History of Changes to the Project Infrastructure Layout

1.1 Overview of Changes

Figure 1-2 Comparison of EA & PPR grid connection options

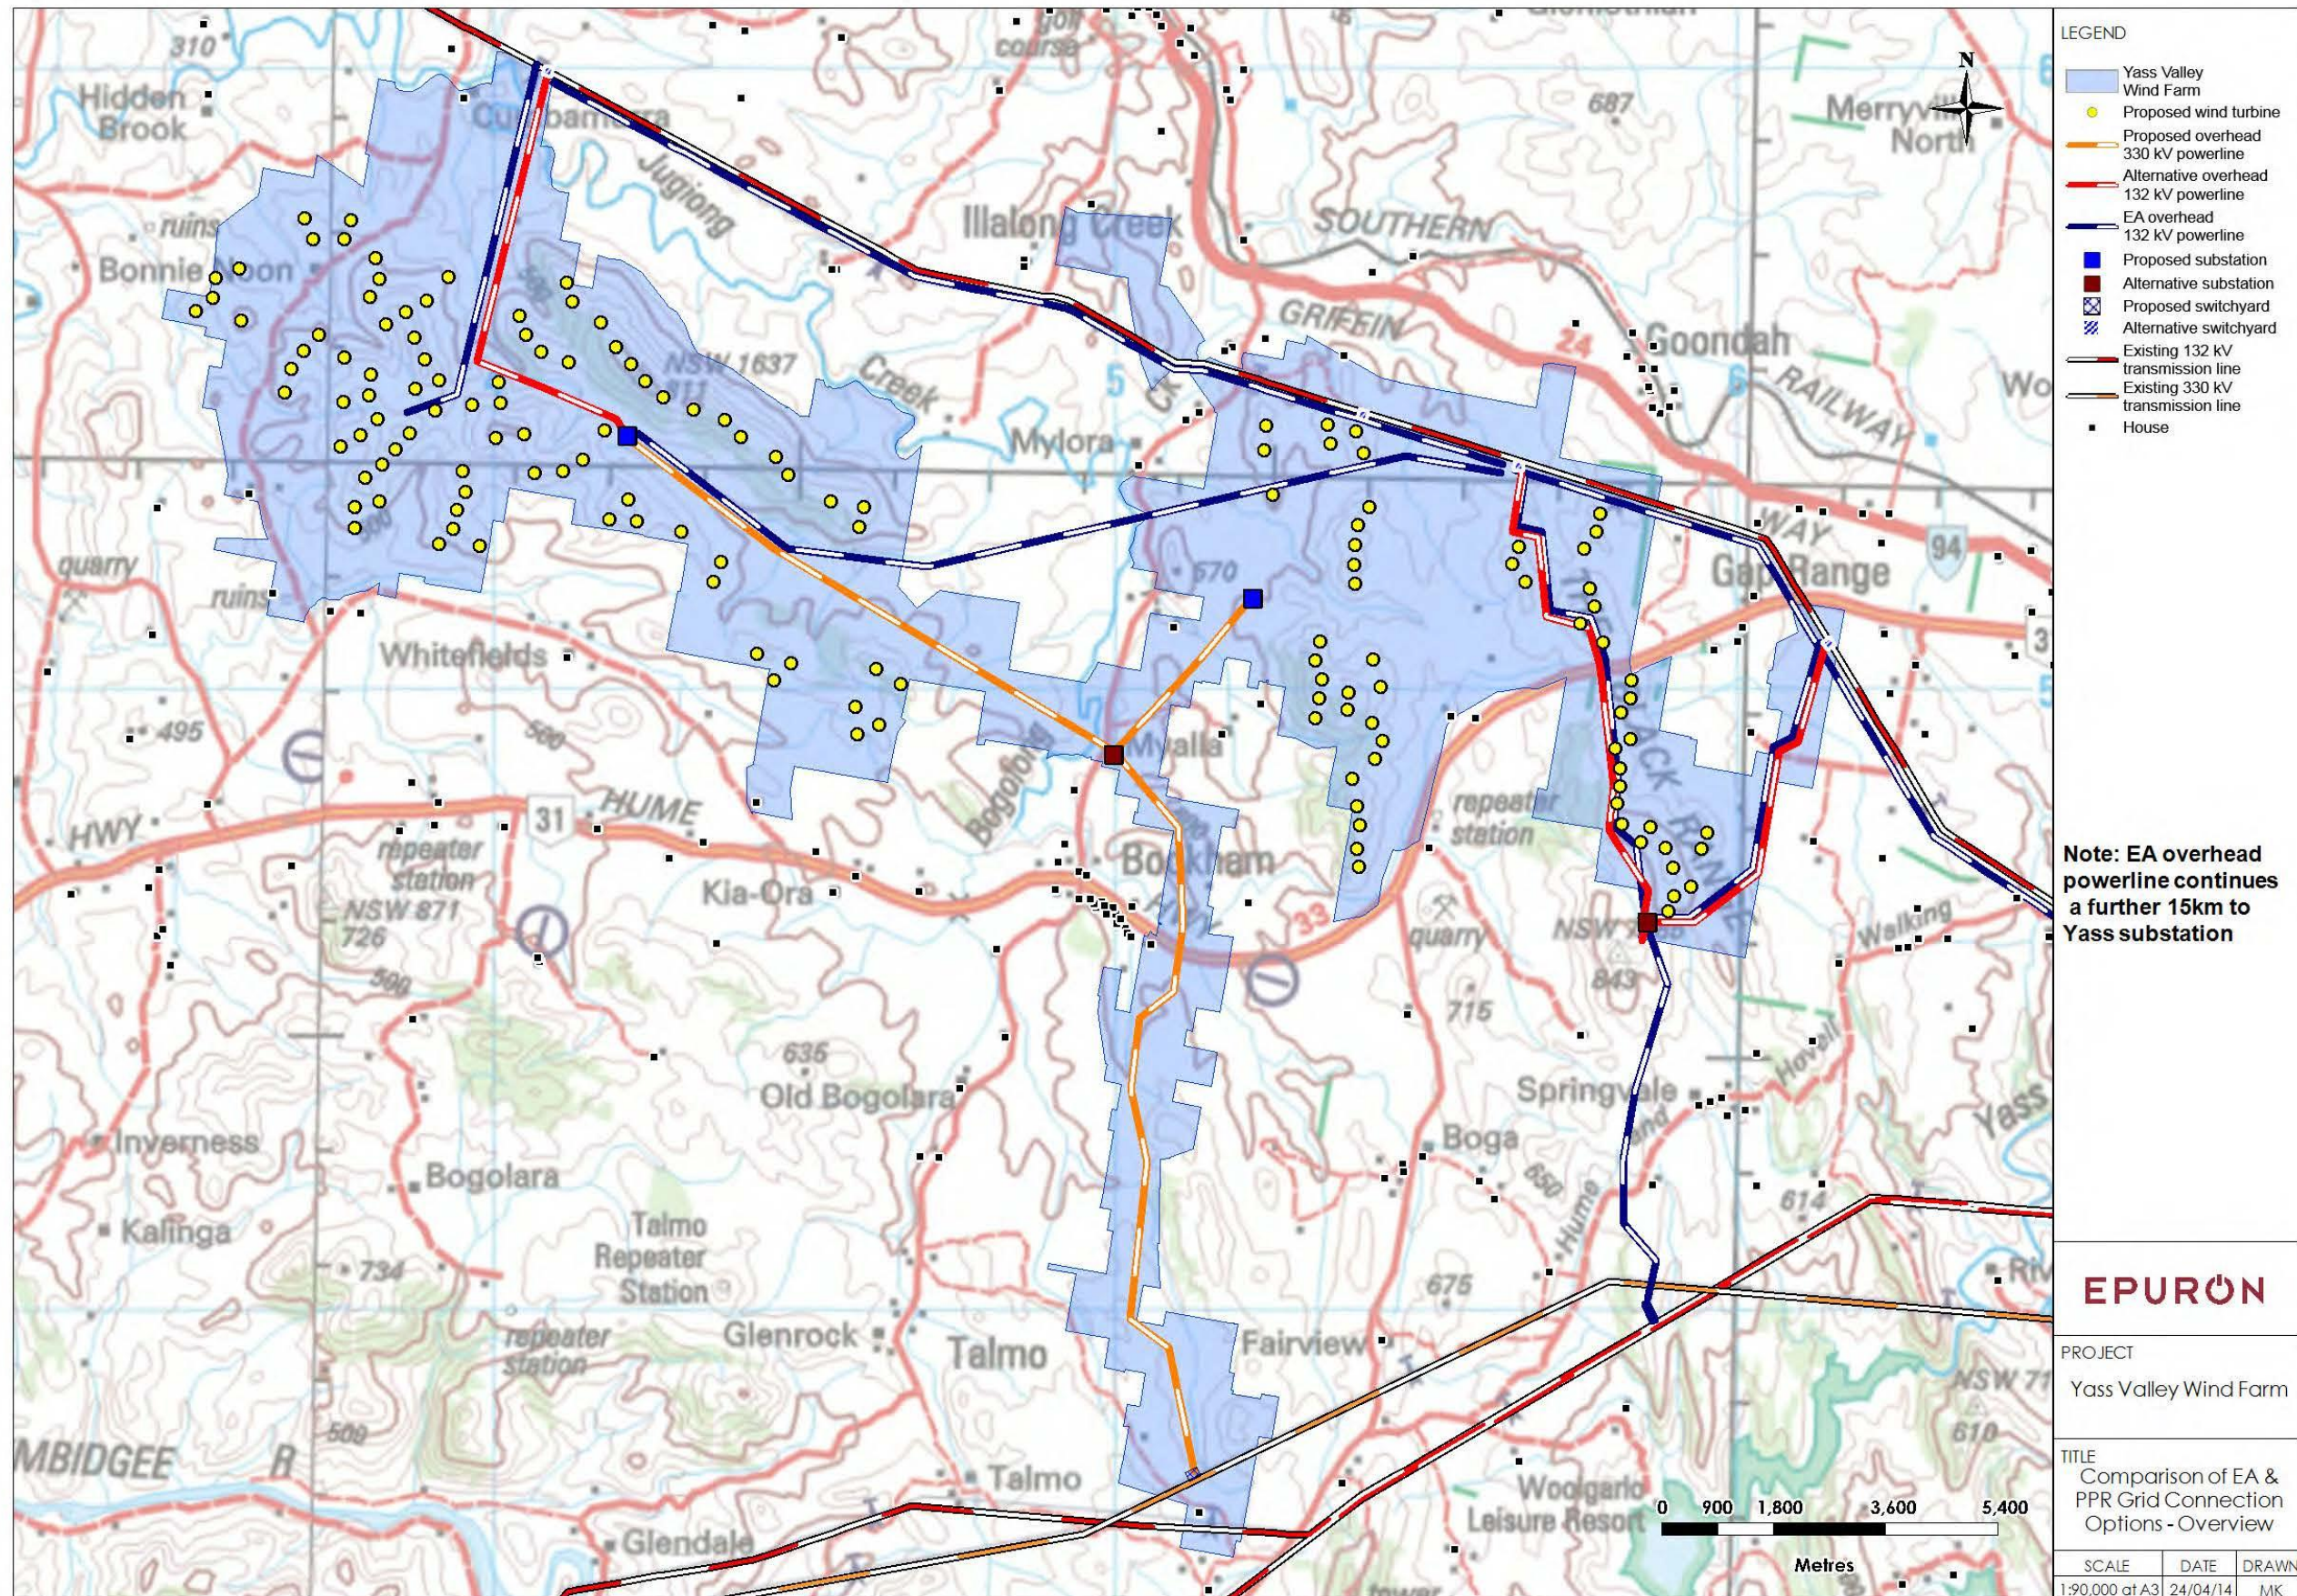
The original 132kV grid connection involved more than 75km of high voltage overhead powerline and 40km of medium voltage overhead powerline (within the site). A large part of the 75km was due to a required upgrade of the existing 132kV line from the wind farm site back to the Yass substation. This connection was revisited and a new and preferred 330kV transmission line connection was proposed in the PPR (Nov 2012) which remains the preferred connection in the PP&SR. The preferred 330kV connection is not only significantly shorter than the 132kV transmission line routes presented in the EA (2009), but it also significantly reduces impacts to biodiversity.

See Figure 8-1 for a map comparing the original transmission line routes to the preferred and alternative transmission line routes presented in the PPR (Nov 2012). For clarity, the preferred and alternative transmission line routes are also shown in Figure 1-4 and 1-5.

Figure 1-3 PPR Preferred 330kV transmission line route and MV reticulation

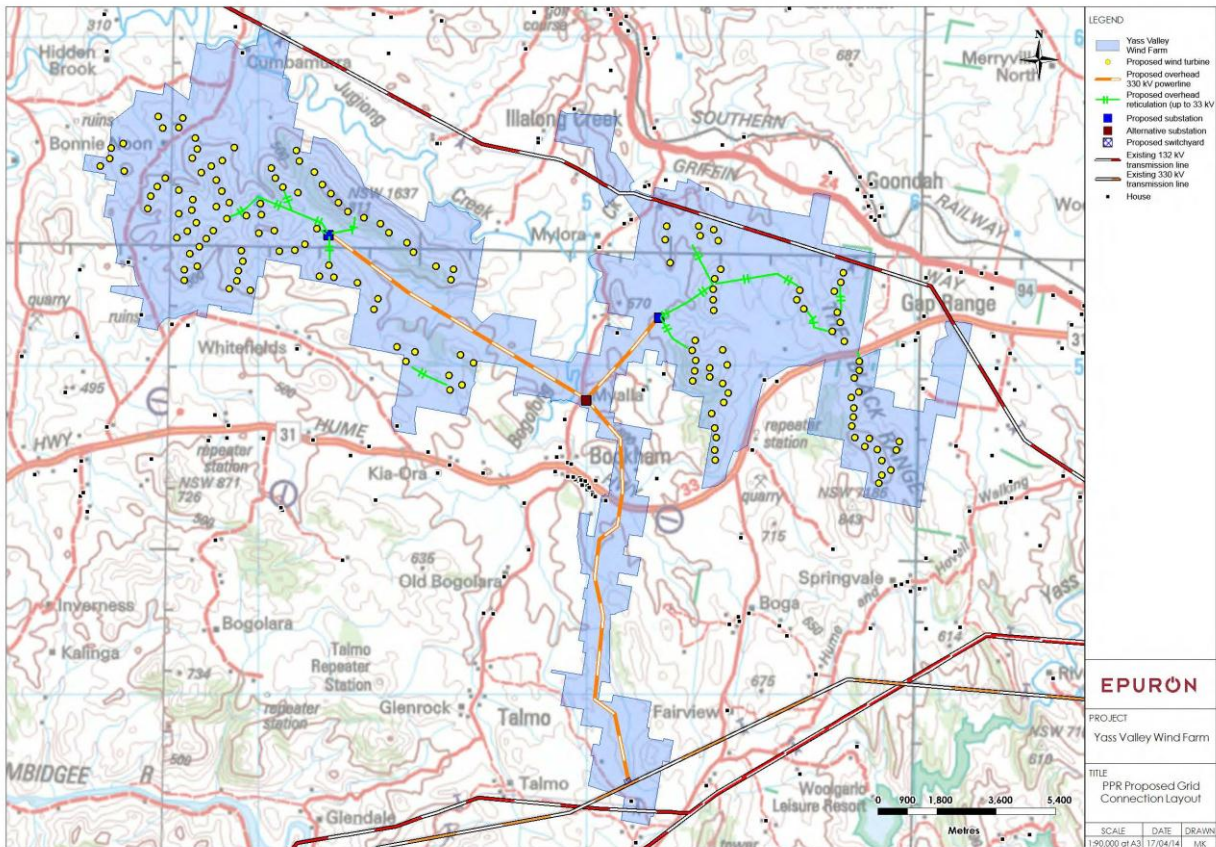
The preferred connection enables the entire site to be connected to the 330kV transmission line to the south of the wind farm. An alternative option to connect sections of the wind farm to the 132 kV transmission line to the north of the site, but without requiring an upgrade back to Yass is also included. This allows for the potential for a staged project where an initial first stage cannot justify the full 330kV connection.

Figure 1-5 Wind turbine location changes - Coppabella precinct

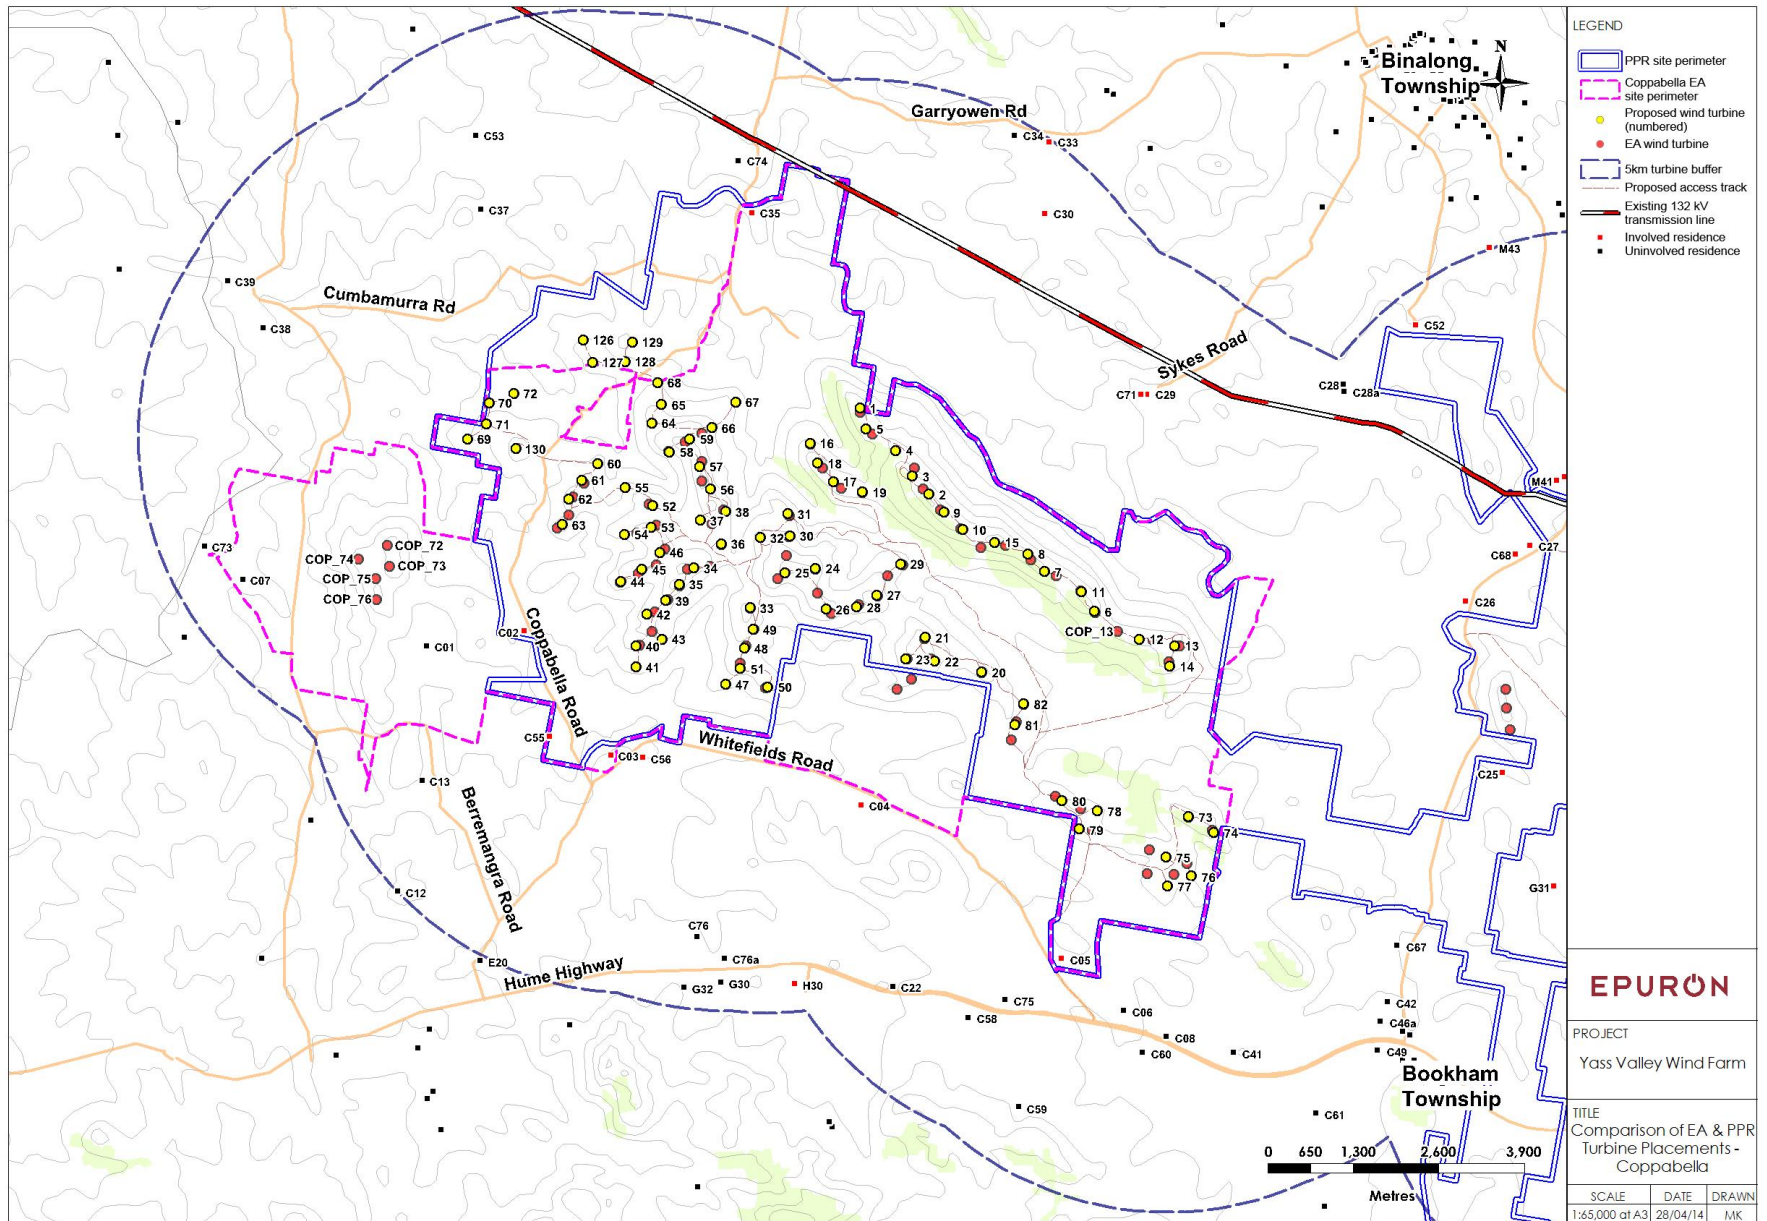
As noted in section 1.1, the overall number of wind turbines was reduced from 152 to 148. The reason for the change in location for wind turbines is listed in section 2.3 of the PPR (Nov 2012). The maps on the following pages highlight the changes in turbine locations for the Coppabella and Marilba precincts.

Figure 0-7 Relocated wind turbines north west Coppabella

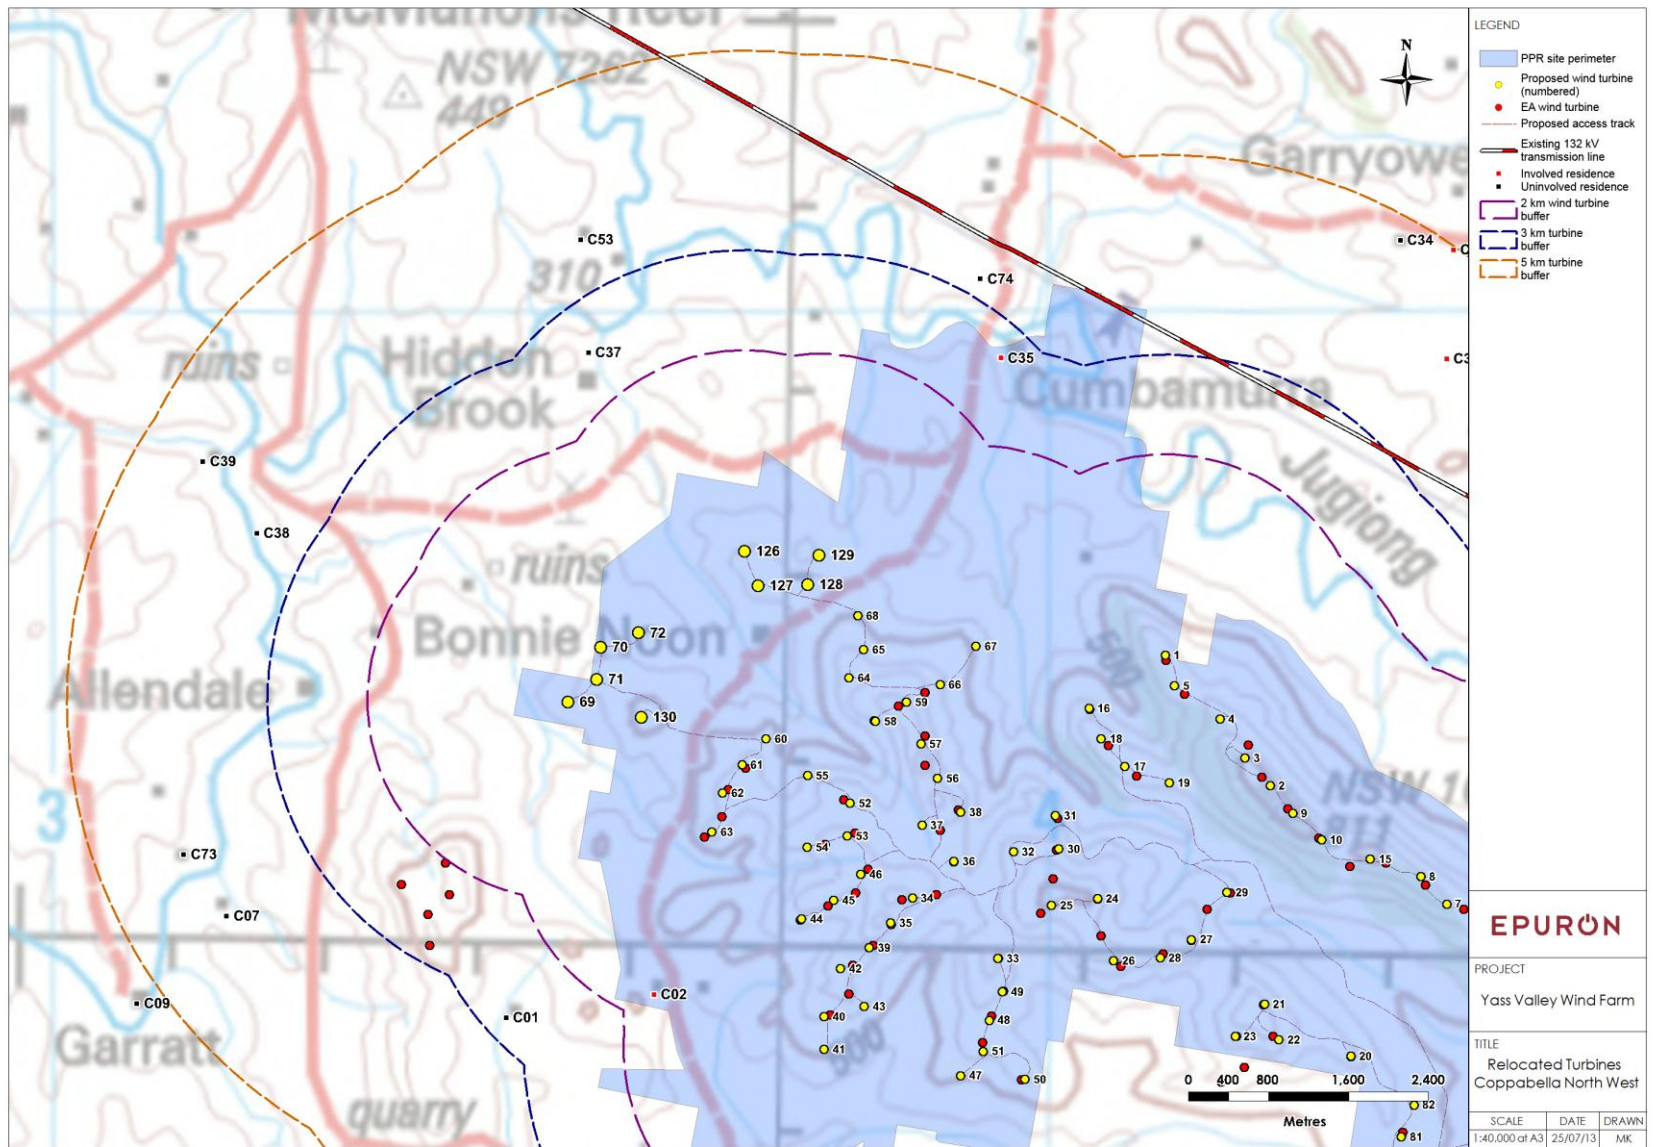
Following exhibition of the EA, a number of individual turbines were removed throughout the site along with a group of 5 turbines which were the most westerly wind turbines of the Coppabella precinct. Sixteen turbines in total were removed and of this number twelve were relocated to the north west of the site. Eight of these turbines were consolidated within the existing boundary of the site and four were positioned on land which extended the site boundary in the north west.

While this relocation minimised the overall environmental footprint and consolidated the layout of the wind farm it did result in the potential for increased impact on the residences in proximity to the relocated turbines. See Figure 0-7 below. The turbines relocated to the north west of the Coppabella precinct were numbered 64, 65, 67, 68, 69, 70, 71, 72, 126, 127, 128, 129 and 130. While the relocation of turbines has the potential for an increase in environmental or amenity impact, expert assessment, in conjunction with consultation, has shown that there has not been an increased impact on each of the closest residences in this case.
